UNITED STATES PATENT AND TRADEMARK OFFICE

10/810,231

Mary Jo. A. Toomey

DETAILED ACTION

Fig. 9

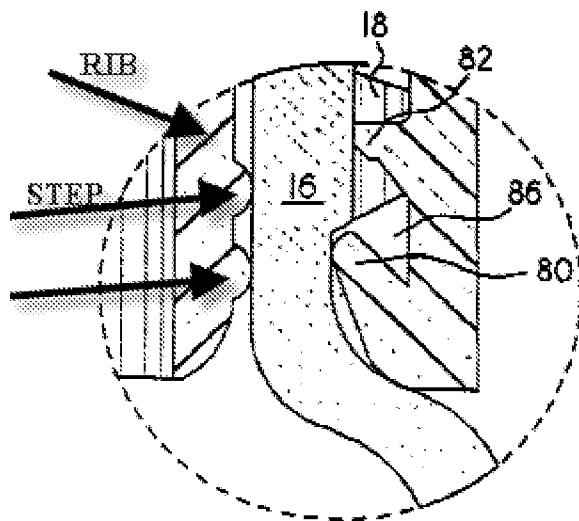
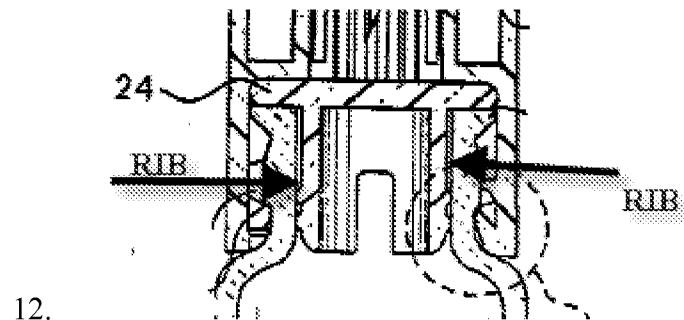
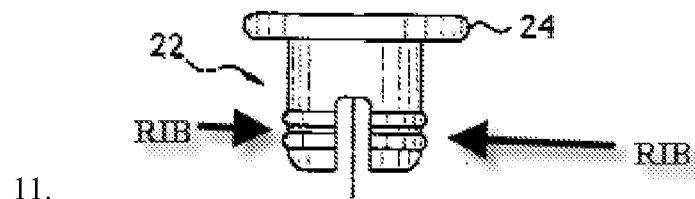
10. With respect to claims 6 and 7, Manera discloses the base 22 defines a plurality of ribs, the ribs defining a step for supporting the housing. The ribs and steps are not labeled with a reference number and therefore Figures 2A (22), 8 and 9 respectively are reproduced below with arrows indicating the ribs and steps for clarity:
